Seismic Walkdown Checklist (SWC)

Equipment ID No. Q2H21E505 Equip. Class¹ 20

Equipment Description 4.16KV SWITCHGEAR 2J LOCAL CONT PANEL

Equipment ID No. Q2H25L029 Equip. Class: 20

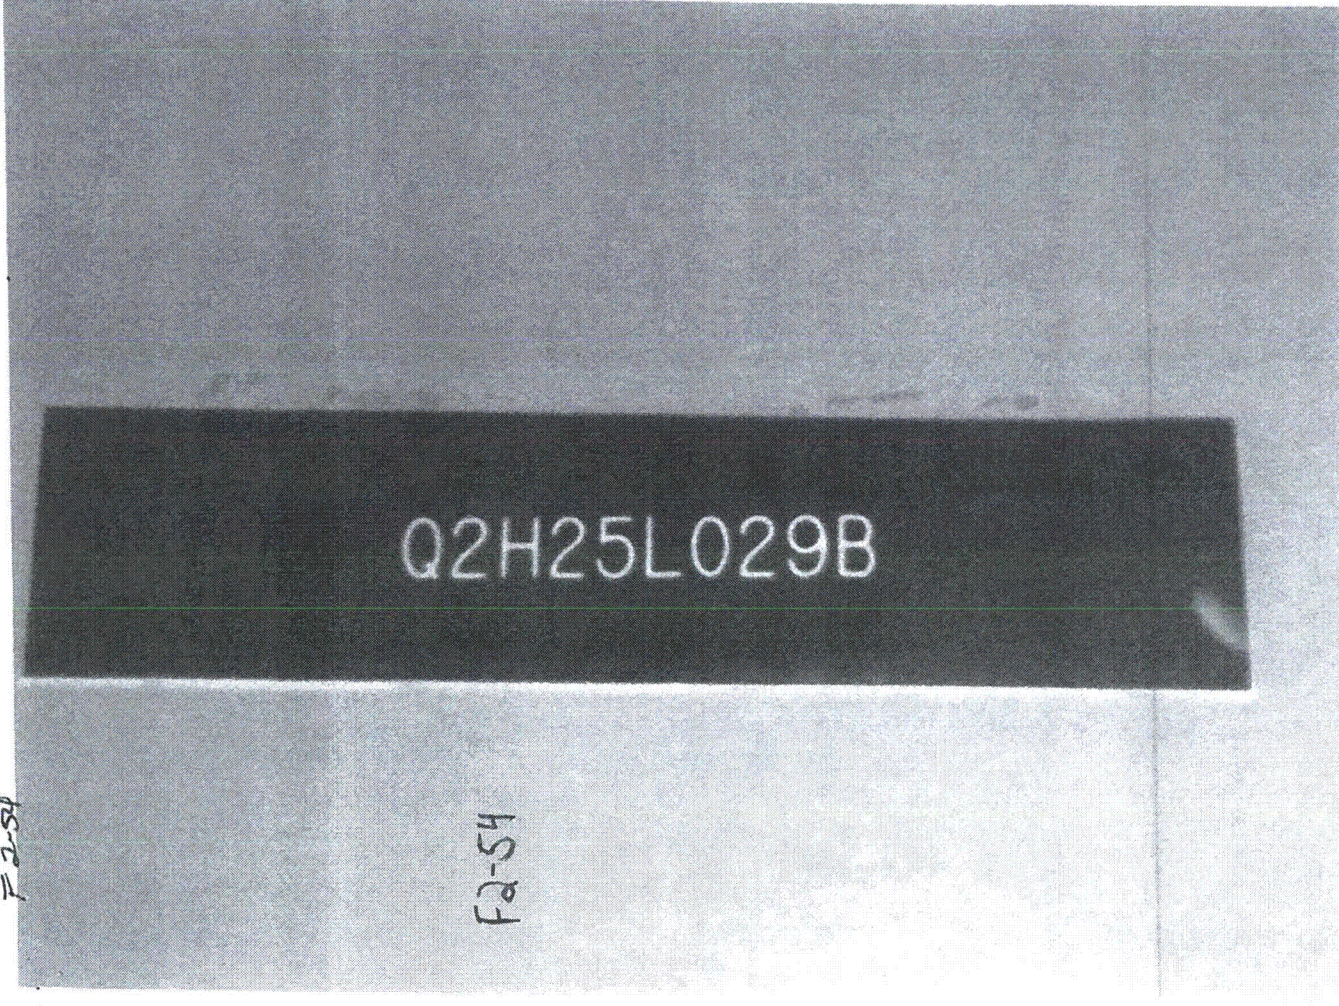
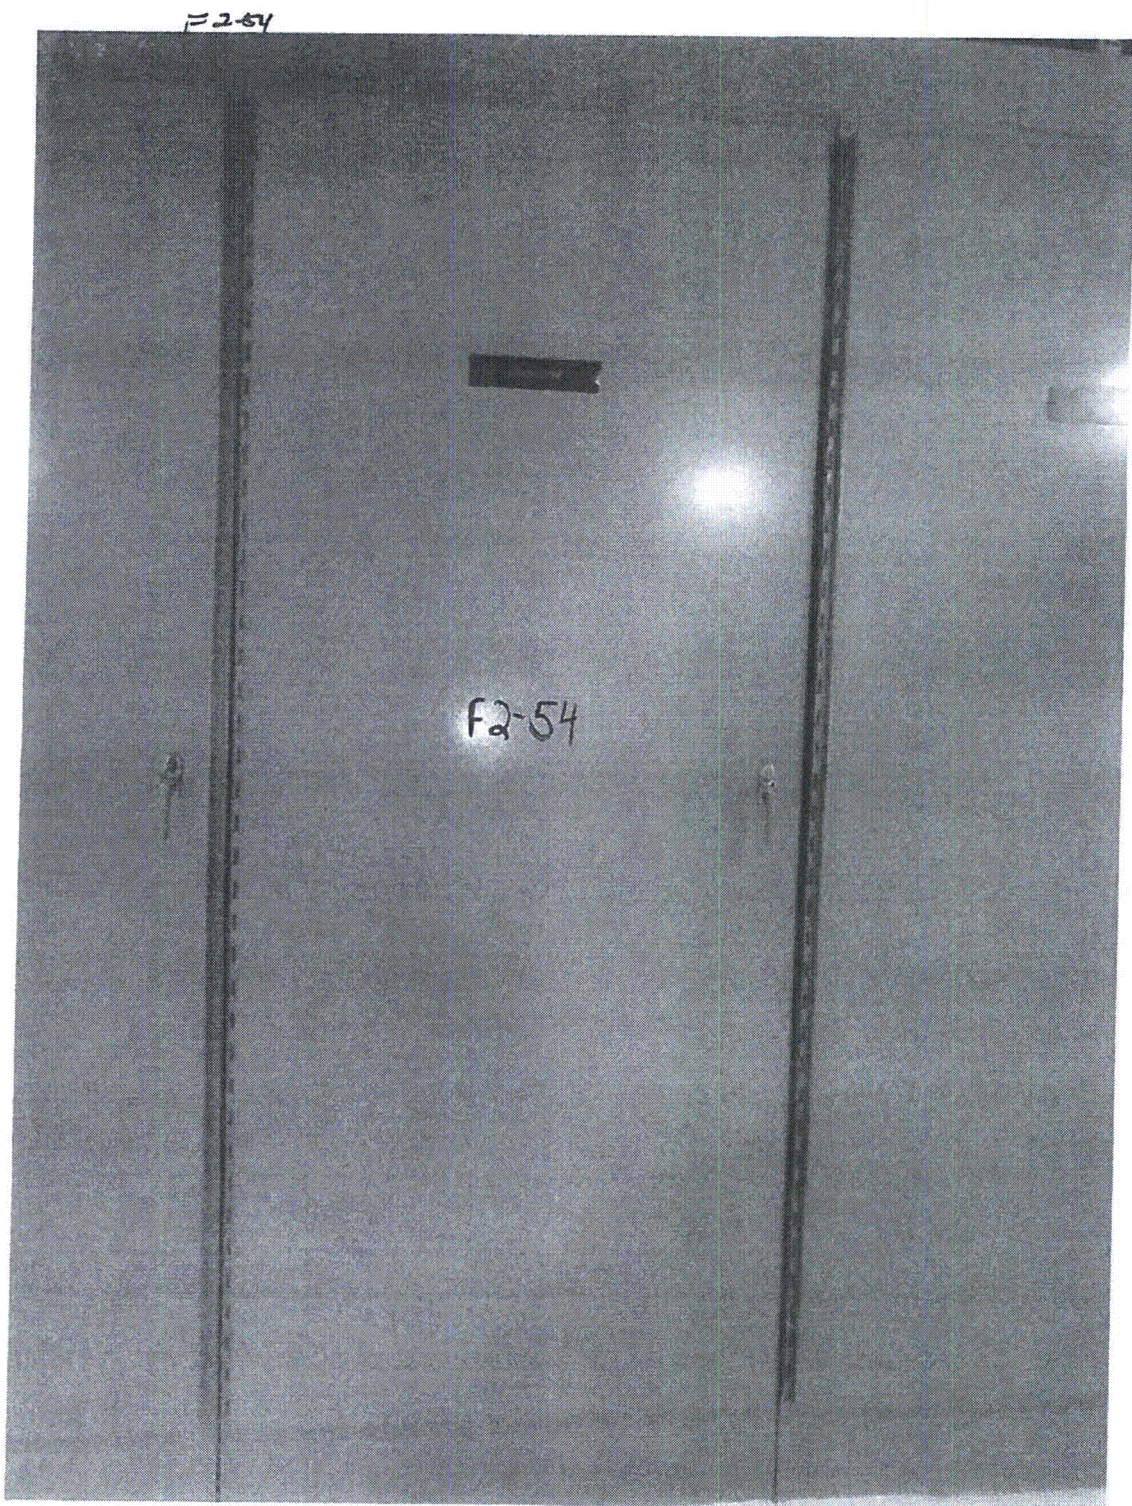
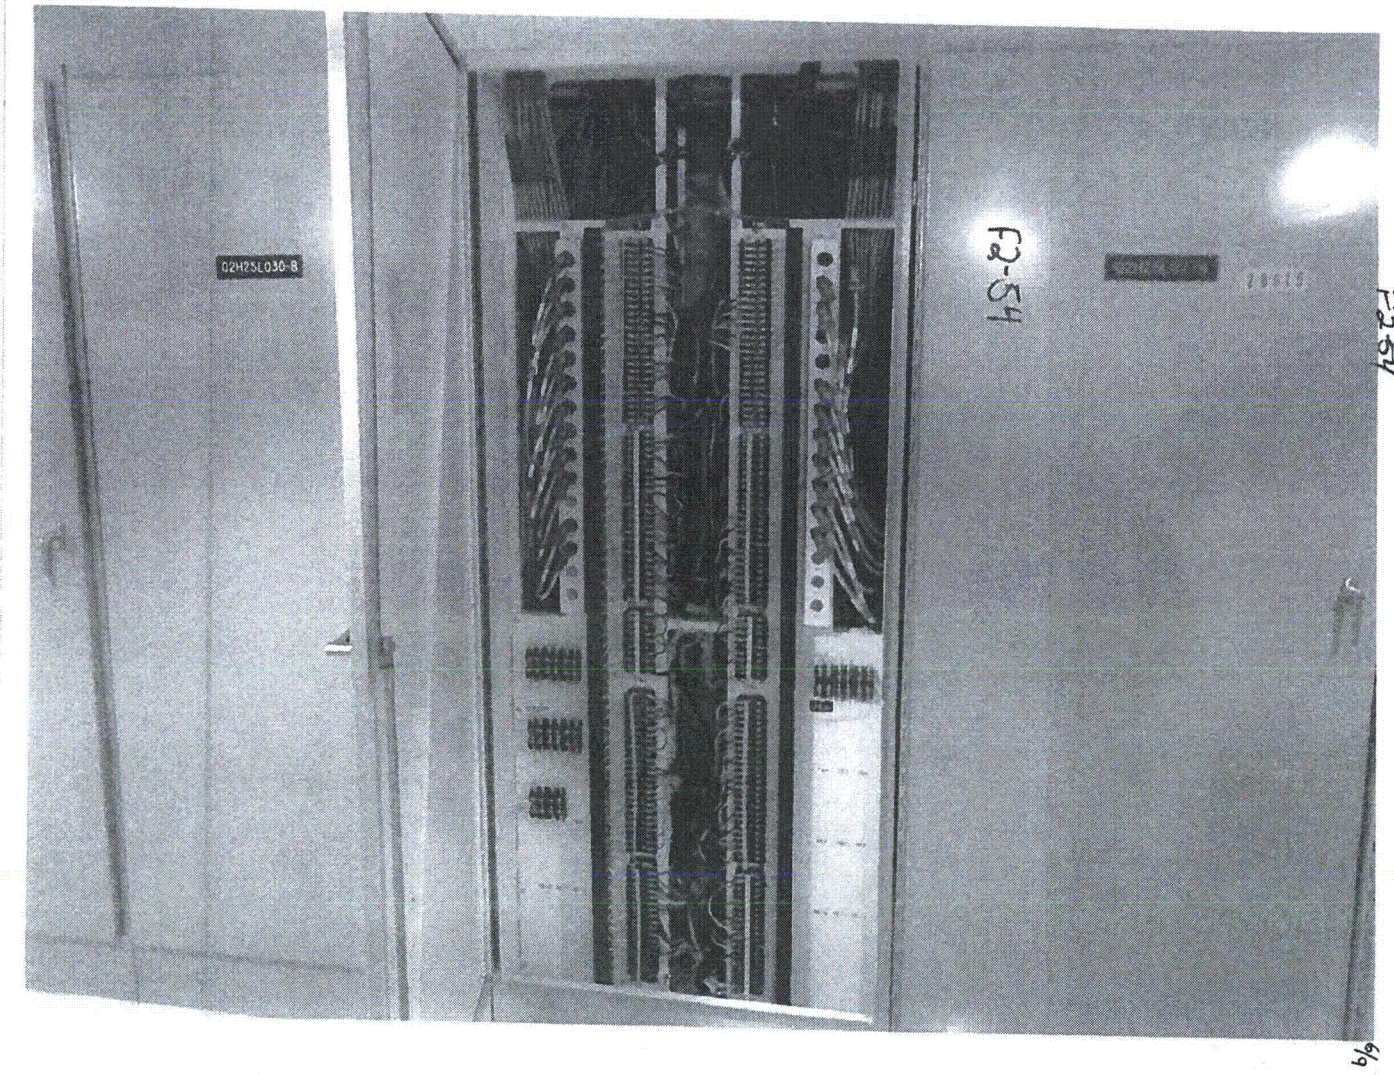
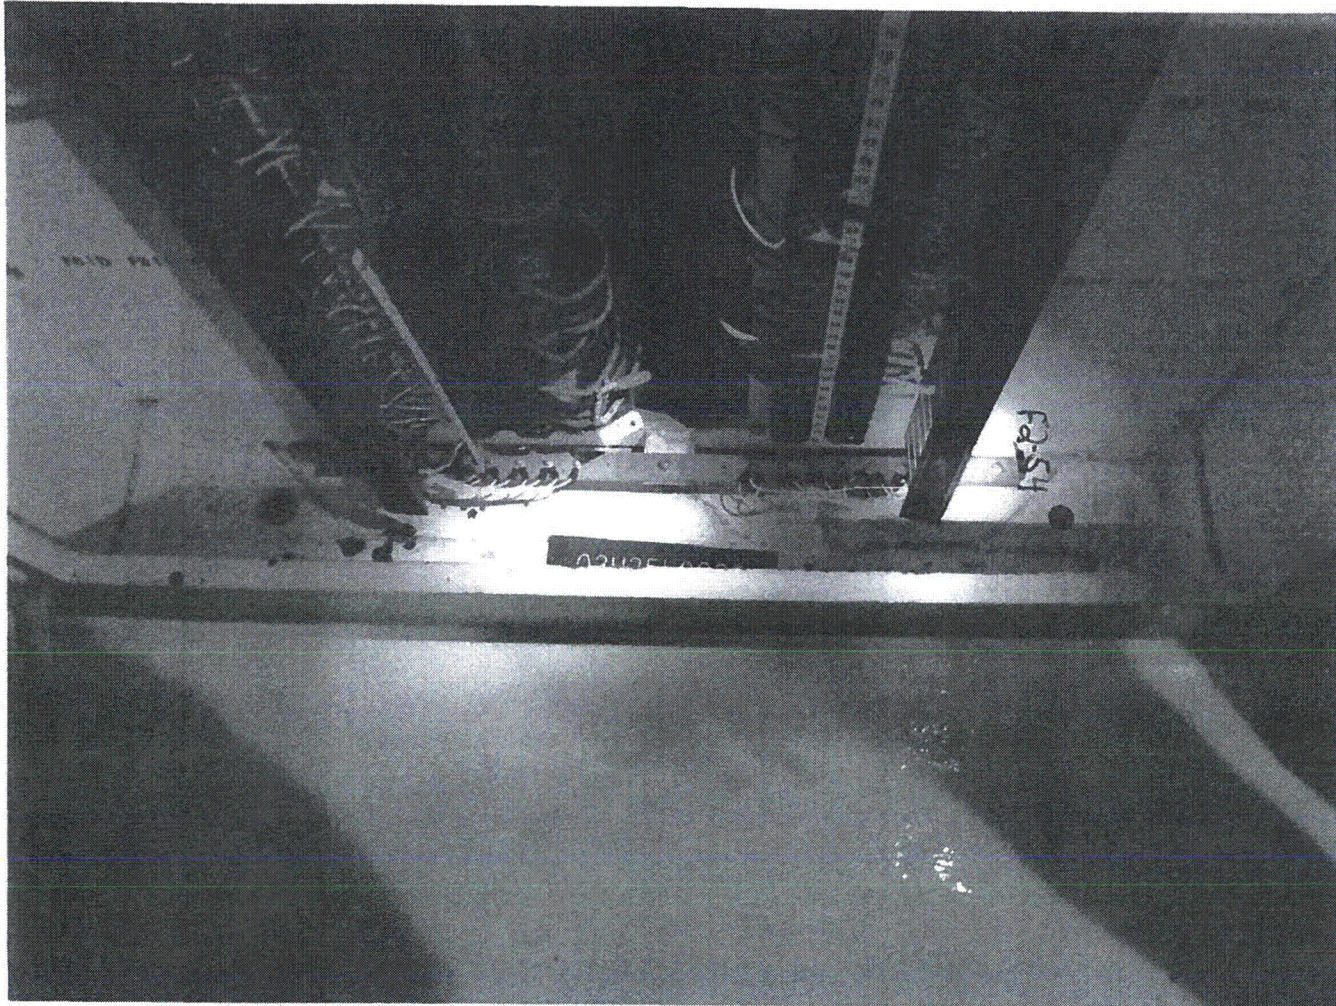
Observed a cable coming out of a cabinet and going to an overhead cable tray. The cable is positioned against the edge of a nearby conduit clamp. The clamp is observed to be free of sharp edges. SWES judged that there is no potential for edge of the clamp to penetrate to the outer

10. Based on the above seismic interaction evaluations, is equipment free of potentially adverse seismic interaction effects? Y N U N/A
cable insulation and cable has adequate flexibility.
